CHOICIRCIATI CULTURAL CENTER EXPANSION

MANHATTAN COMMUNITY BOARD 3 LANDMARKS PRESERVATION COMMISSION PRESENTATION

CHOIRCIRCIATI CULTURAL CENTER
09.25.2018 - UPDATE

PROPOSED FRONT ELEVATION

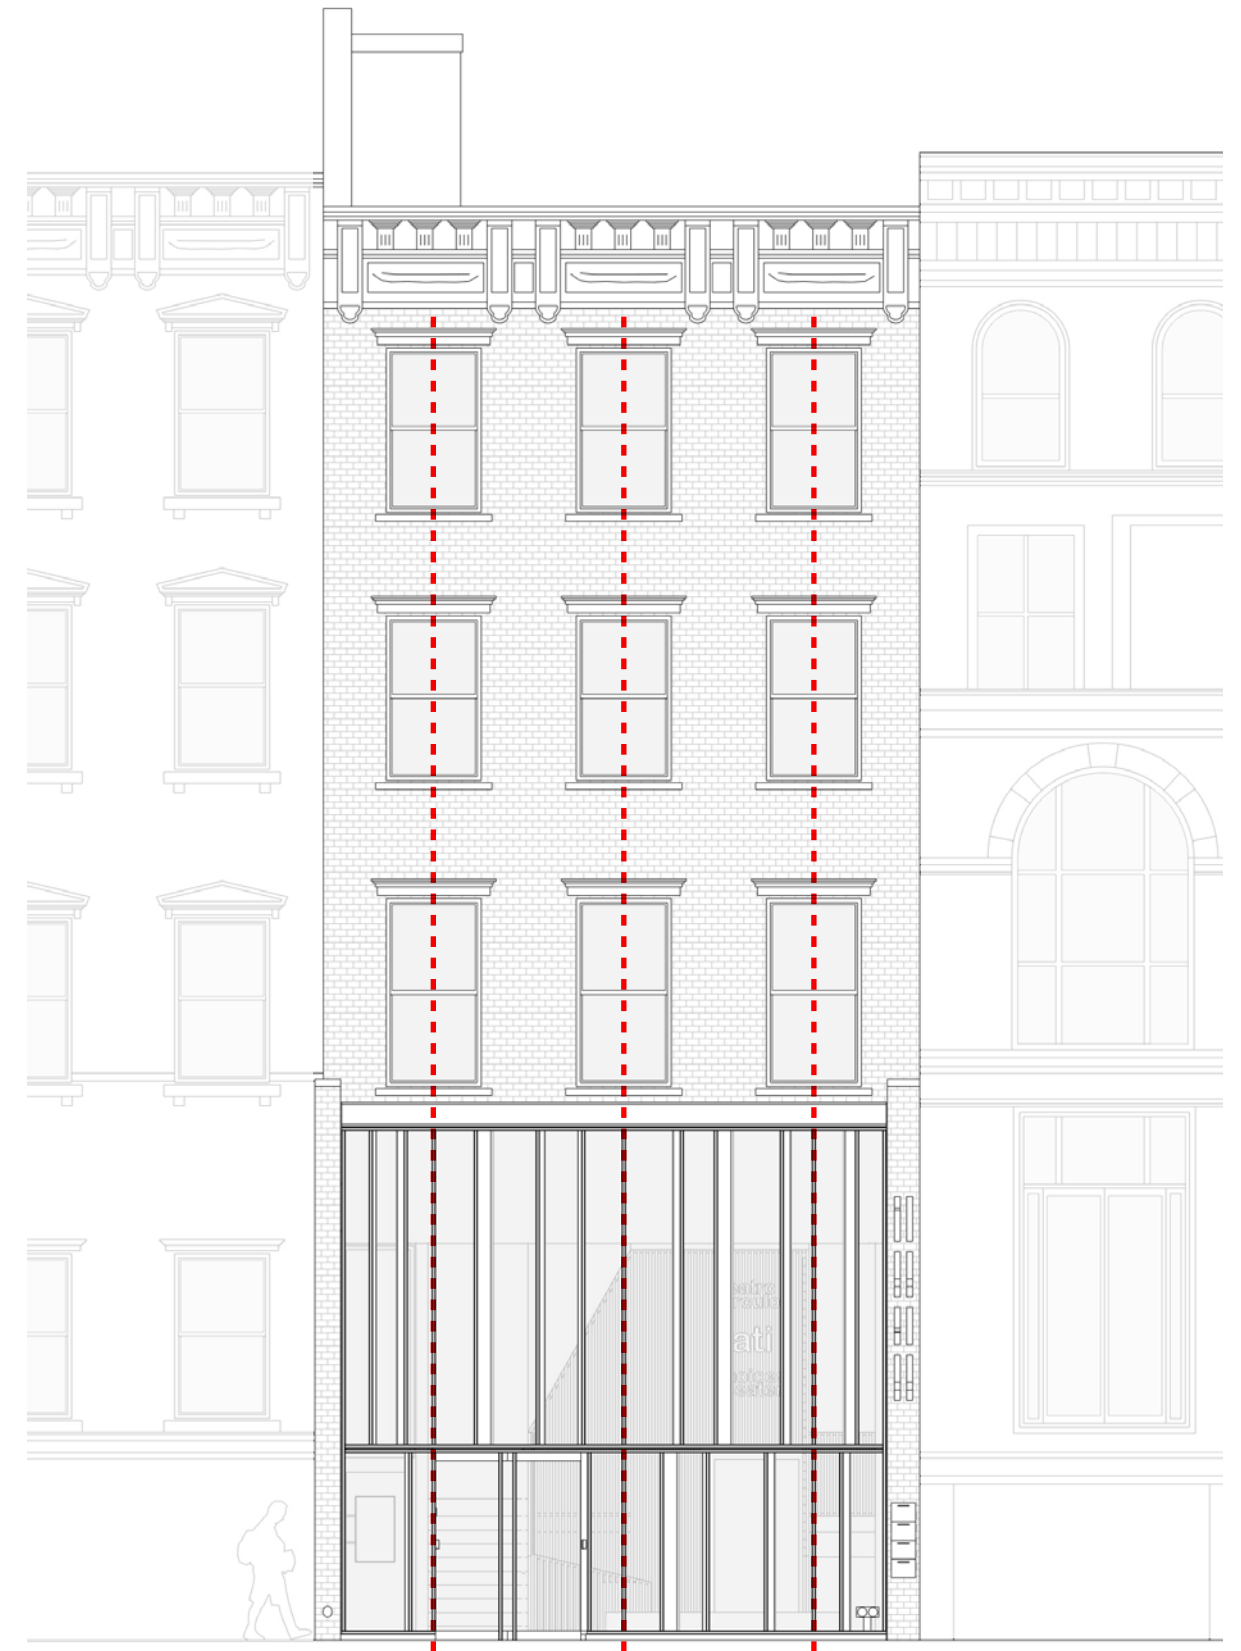
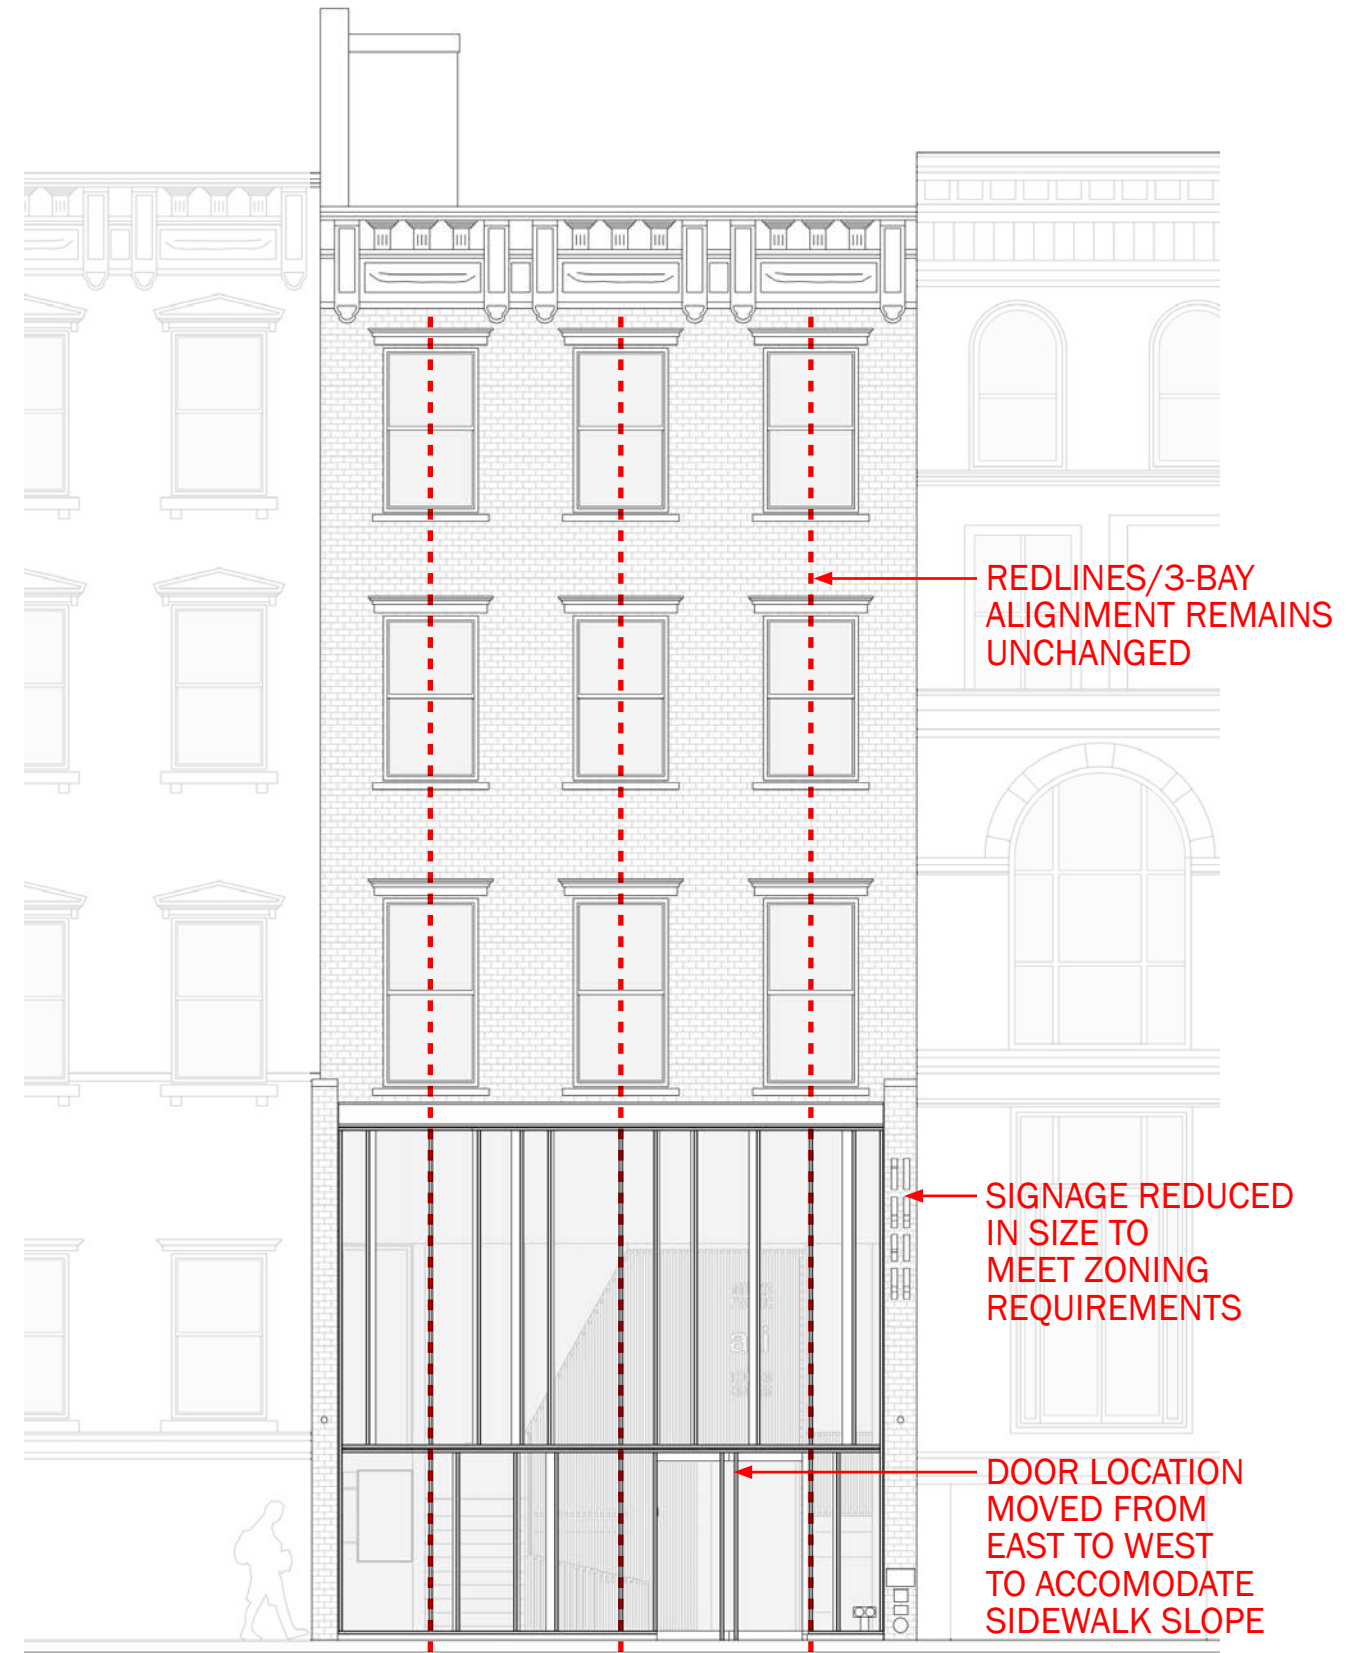
SIGNAGE REDUCED IN SIZE TO MEET ZONING REQUIREMENTS

DOOR LOCATION MOVED FROM EAST TO WEST TO ACCOMODATE SIDEWALK SLOPE

COMMUNITY BOARD 3
HAD VOICED CONCERN
ABOUT DARK FACADE.
R+L CHANGED
FACADE COLOR FROM
CHARCOAL EPOXY
COATED ALUMINUM
TO UNCOATED MATT
FINISHED ALUMINUM
FACADE

LOWER PLAN OF FACADE

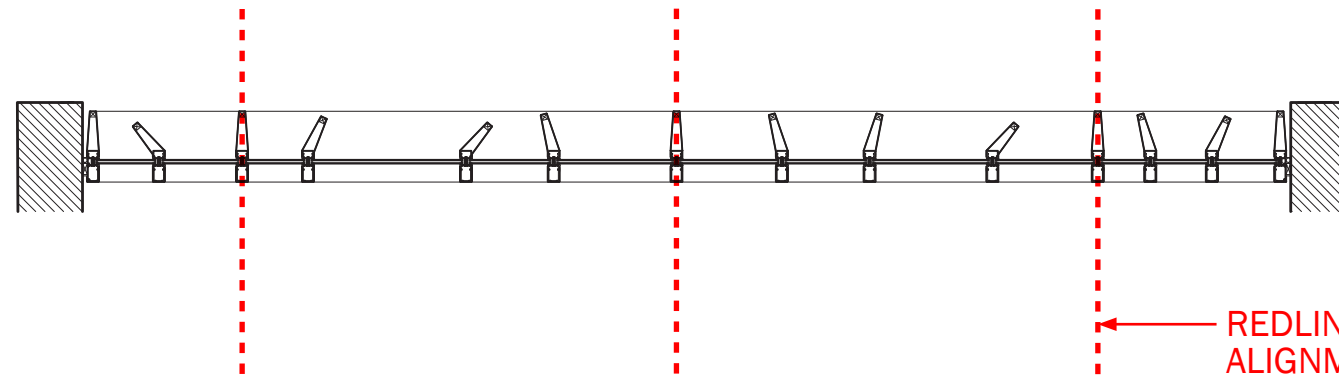
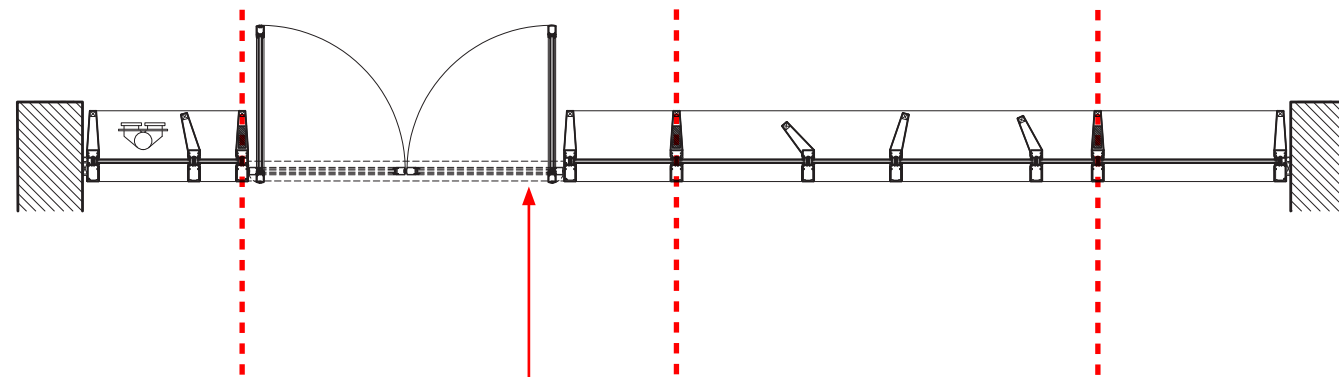
DOOR LOCATION MOVED FROM EAST TO WEST TO ACCOMODATE SIDEWALK SLOPE

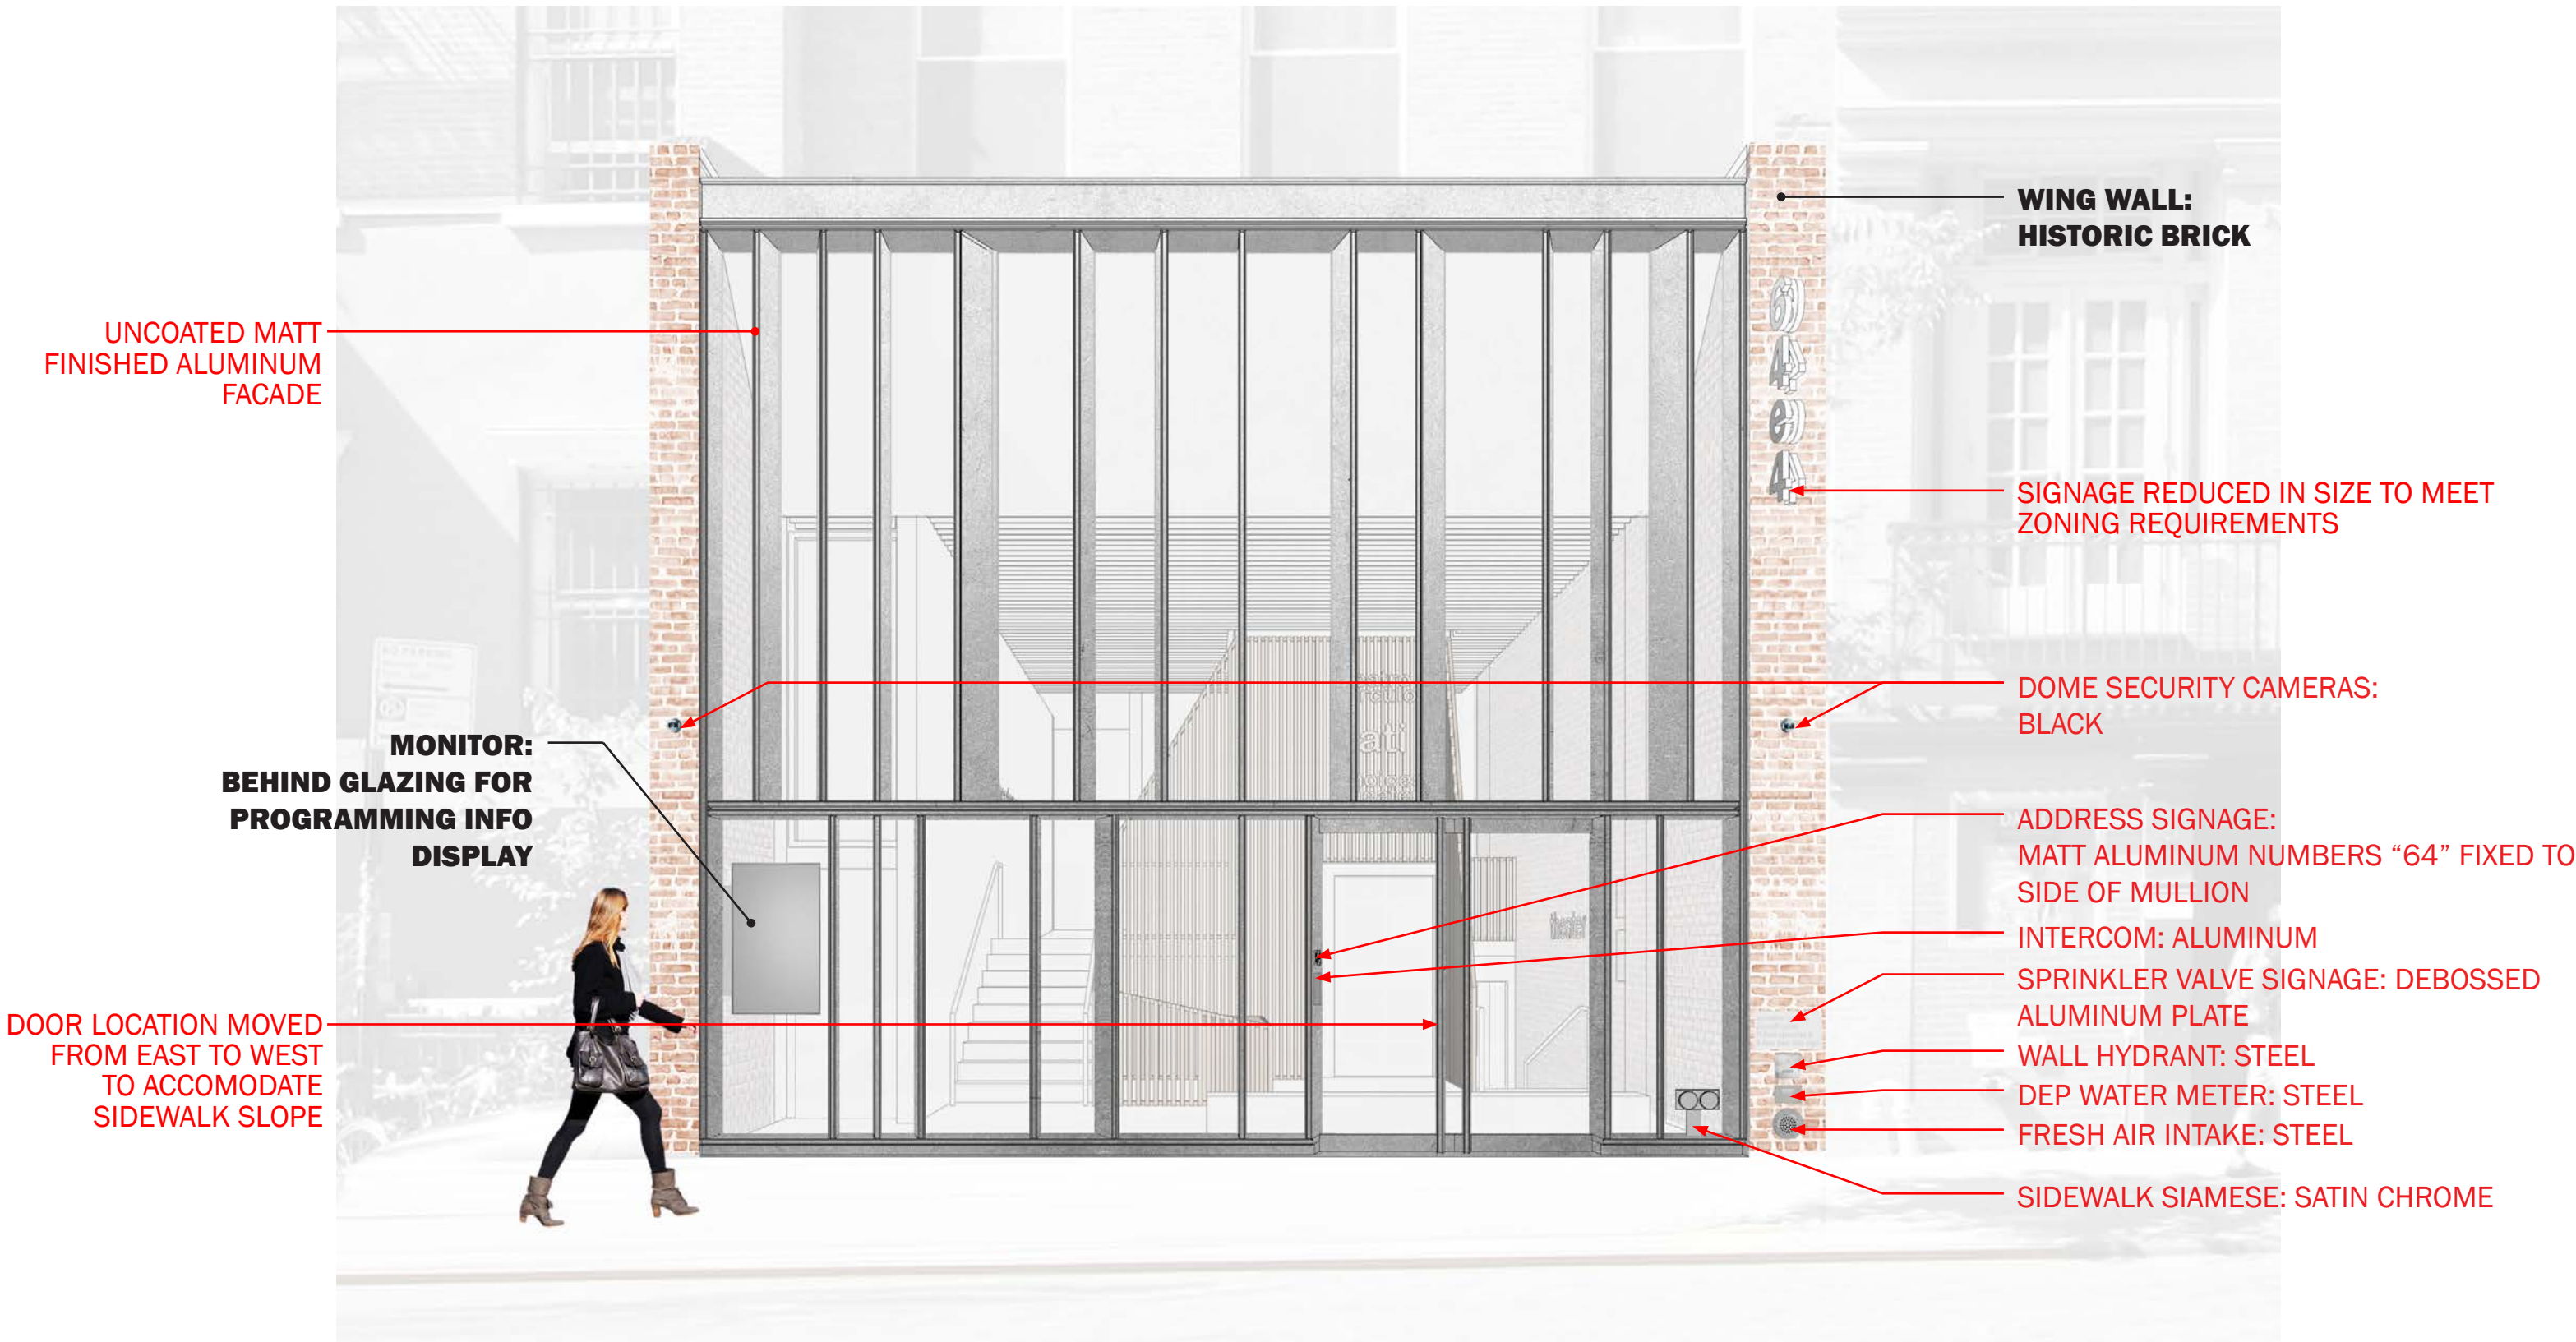
UNCOATED MATT FINISHED
ALUMINUM FACADE

SIGNAGE REDUCED IN SIZE TO MEET ZONING REQUIREMENTS
DOOR LOCATION MOVED FROM EAST TO WEST TO ACCOMODATE SIDEWALK SLOPE

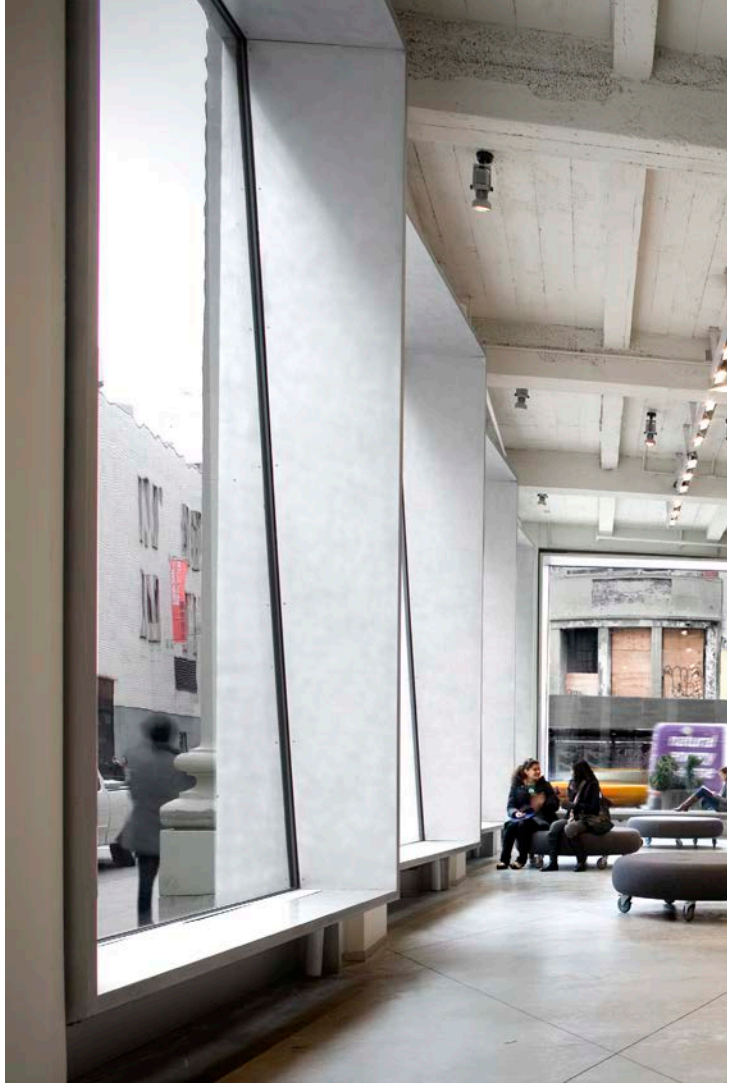
**WING WALLS:
NEWER BRICK AND CEMENTIOUS INFILL TO BE REPLACED
TO MATCH HISTORIC BRICK**

**NEW STOREFRONT:
ALUMINUM MULLIONS
MATTE FINISH WITH RECESSED
GLAZING**
